Replacement of MS6-SV-1/2-E-ASIS-AG by MS6-SV-1/2-E-10V24-AD1

TitleReplacement of MS6-SV-1/2-E-ASIS-... by MS6-SV-1/2-E-10V24-AD1
Version 1.10
Document no. 100178
Originalen
AuthorFesto

Due to the planned phase-out of the MS6-SV-...-E-ASIS-... an alternative solution with the MS6-SV-...-E-10V24-AD1 and the AS-i Safety output module BWU2045 from Bihl+Wiedemann is proposed. The circuits described here and the procedure described are recommendations which do not exclude other possibilities.

1.8 Electrical circuit with cable plug NECA-S1G9-P9-MP1

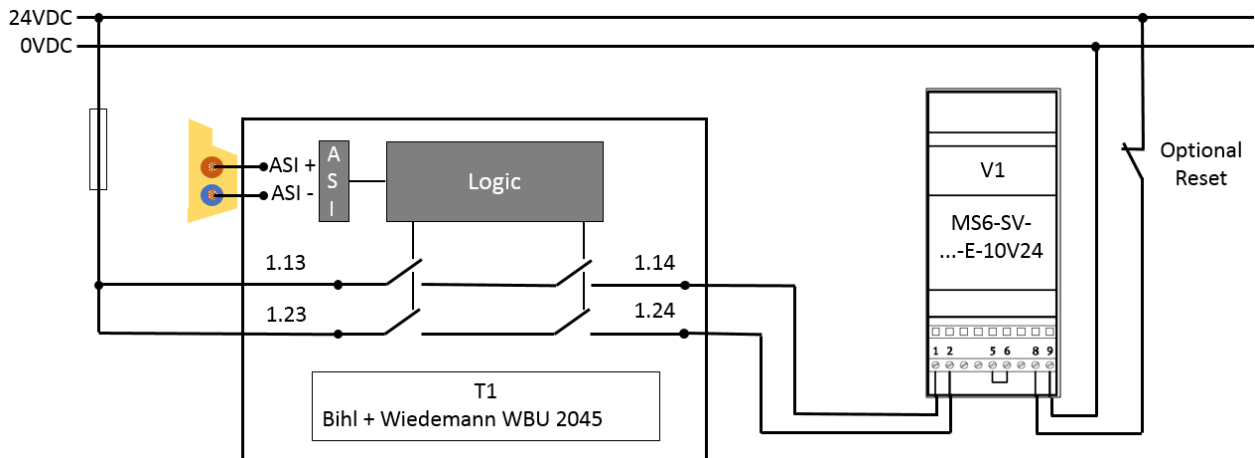
The multi-pin plug socket NECA-S1G9-P9-MP1 expects 2 signals with +24V DC at pins 1 and 2, these can be static or dynamic.

For a more detailed description of the signals, please see the MS6-SV-...-E-10V24... operating instructions.

1.9 Electrical circuit with cable plug NECA-S1G9-P9-MP3 / NECA-S1G9-P9-MP5

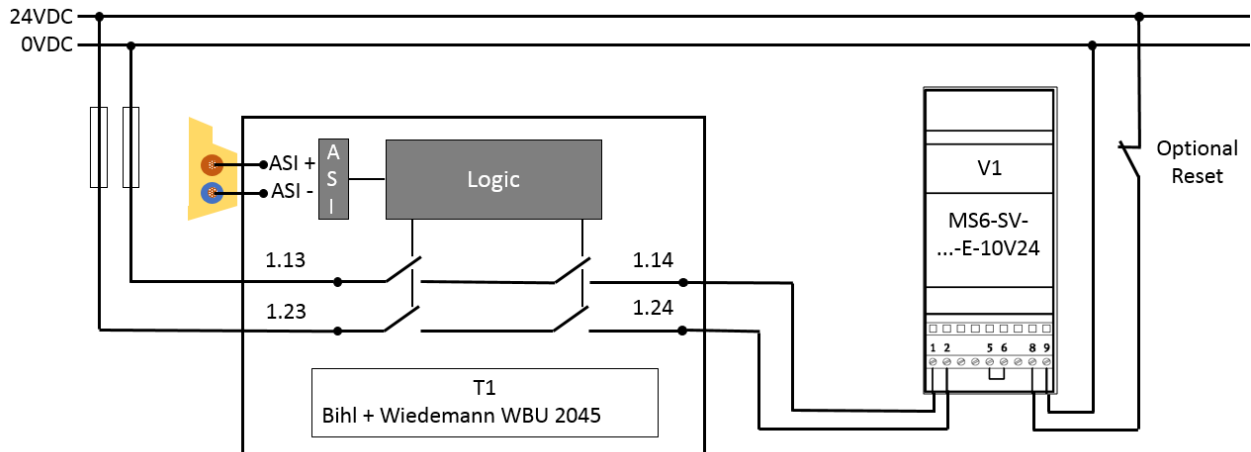
The multi-pin plug socket NECA-S1G9-P9-MP3 / NECA-S1G9-P9-MP5 expects 1 signal with 0V DC at pin 1 and +24V DC at pin 2, these can be static or dynamic.

For a more detailed description of the signals, please see the MS6-SV-...-E-10V24... operating instructions.
